NUCLEAR REGULATORY COMMISSION

Title: Advisory Committee on Reactor Safeguards
ABWR Subcommittee Meeting

Date: Friday, August 23, 2019

ABWR DC RENEWAL

Containment Overpressure Protection System (COPS)

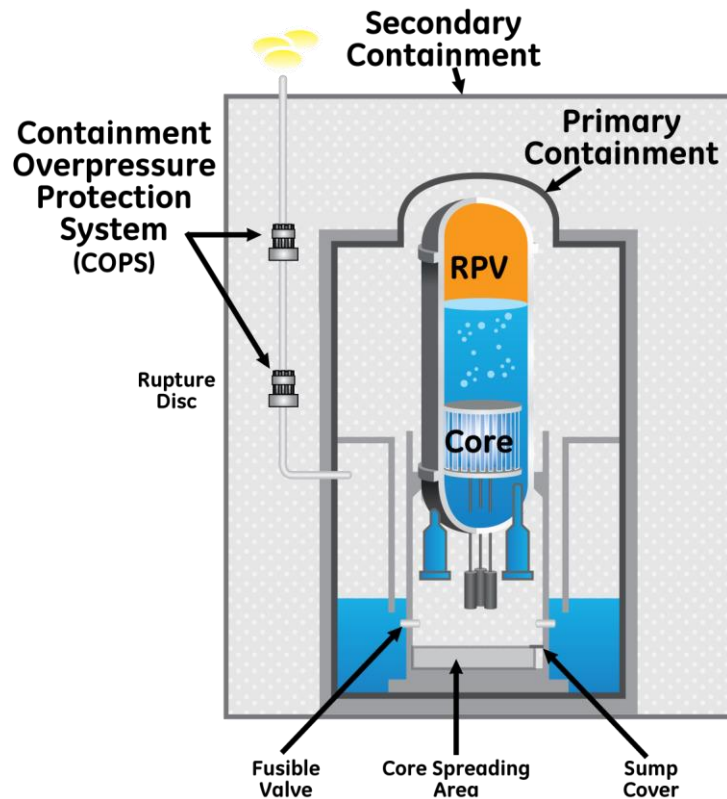
Revised (increased) the diameter of the vent lines and rupture disc

- During detailed design the flow resistance in the laid out piping was higher than originally assumed
 - Longer pipe runs with more fittings
